Product Update

#P413

Revision 03

Transoms

Standard Spring-bolt Locations (measured from the wide face of rabbeted transoms)

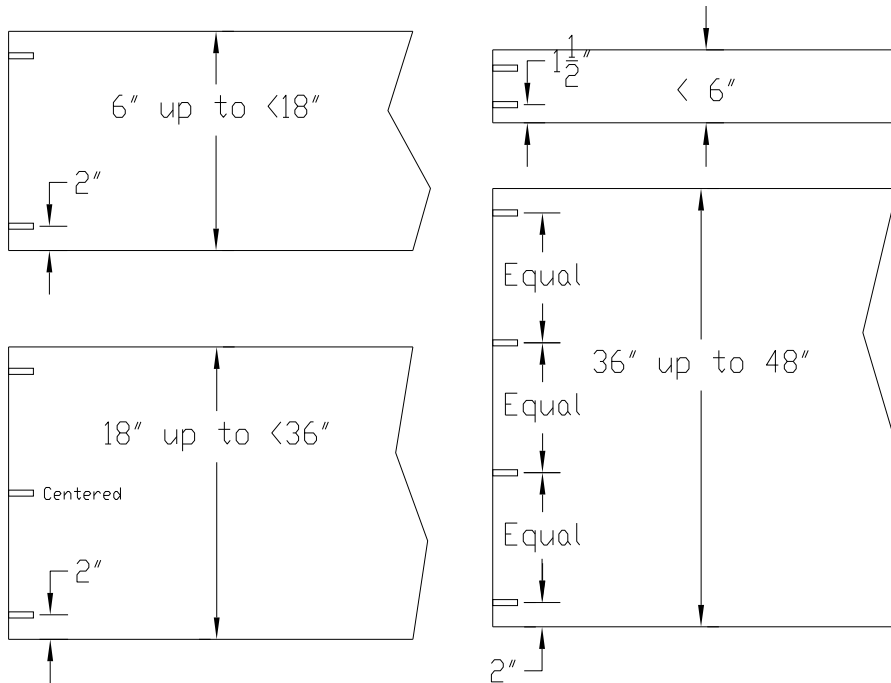
As standard spring-bolts are machined in the vertical edges of the panels as noted:

- Panels up to 18" having 2 bolts per side
- Panels up to 36" having 3 bolts per side
- Panels up to 48" having 4 bolts per side

Single transoms over a fire rated pair, spring-bolts required on horizontal edges with Fire Composite core construction. Spring bolts required 2" from the stile edges and maximum of 30" in between spring bolts.
